August 19, 2013 NYISO Demand Curve Reset Proposal
Comments of the Indicated New York Transmission Owners
August 30, 2013

Central Hudson, Con Edison, National Grid, NYPA, and NYSEG/RG&E offer the following comments on the August 19, 2013 draft of the Proposed NYISO Installed Capacity Demand Curves for the Capability Years 2014/2015, 2015/2016 and 2016/2017 (“NYISO Proposal”). The indicated New York Transmission Owners are continuing their review of various aspects of the NYISO Proposal and the detailed assessment (“Final Report”) prepared by Sargent & Lundy (“S&L”) and National Economic Research Associates (“NERA”), and may provide additional comments at a later date.

Chart 1. Age of New York City Peaking Units

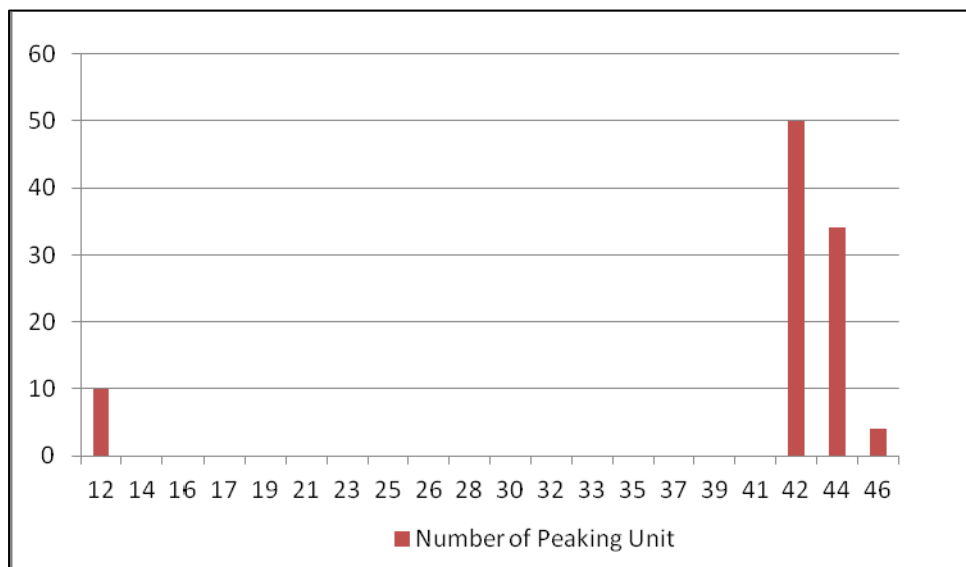
Simple cycle units older than 40 years are common in New York, as shown in the table below.

The use of a 20-25 year life cycle amounts to an assertion that investors will place a value of zero on potential cash flows more than 20 or 25 years in the future. This conclusion is contradicted by the results of NERA's financial model, which indicate that each of the plants evaluated will remain economic beyond the 20-25 year life cycle. Even if we assume that the unit will receive no energy revenues, its capacity payment (at Net CONE) will exceed its remaining O&M, site leasing, insurance, and tax costs. The NPV of the residual cash flow after year 25 (i.e., $(\text{Net CONE} - \text{O\&M} - \text{Property Tax} - \text{Ins}) \cdot (1 - \text{tax rate})$), is over \$1200/kW or over 60% of the initial investment. The high residual value demonstrates the reason why most of existing peaking units continue to operate well past 40 years. Even when many of them have low capacity factor (1% or less), they continue to receive a steady capacity payment.

If the NYISO retains the life cycle recommended by its consultants, it should update the proxy unit's residual value to reflect the likelihood that they will have a useful life of 40 years.
